August 11,1992 12 High Point Drive Poughkeepsie, N.Y. 12603

Wicks Aircraft Supply 410 Pine Street Highland, Illinois 62249

We talked on the phone about the having the spar stock that I have on order planed on the butt ends to accommodate the 1/16 plywood reinforcements that must be installed. I understand that there will be an additional fee. I have ordered the following spar material surfaced on 4 sides and conforming to the mil. spec. S-6073 since these will be installed on a certificated aircraft:

> SHETCH FOR 3/4" SPAR BUTT PLANING FOR DAVID RUDE

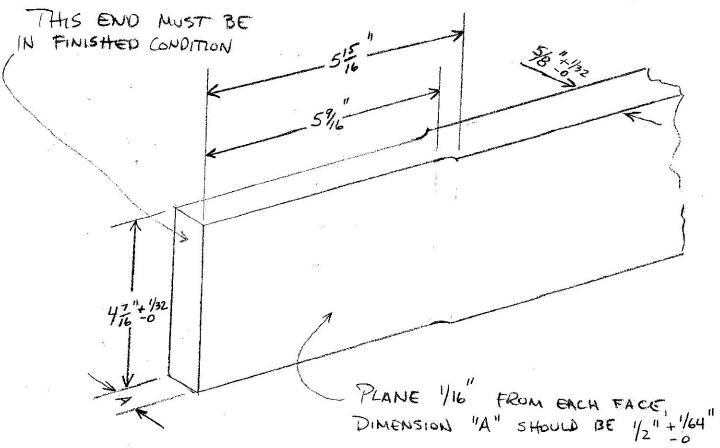
I have enclosed sketches to illustrate the planing that I am requesting. Please call me collect when you review the sketches so we can discuss them. My number is 914-473-0713. It is my home number so call after 5:00 pm EST or call collect and leave a message with my wife for me to call you. Thanks for your help and consideration.

THIS END MUST BE IN FINISHED CONDITTON PLANE VIG" FROM EACH FACE DIMENSION "B" IS 5/8" +1/64"
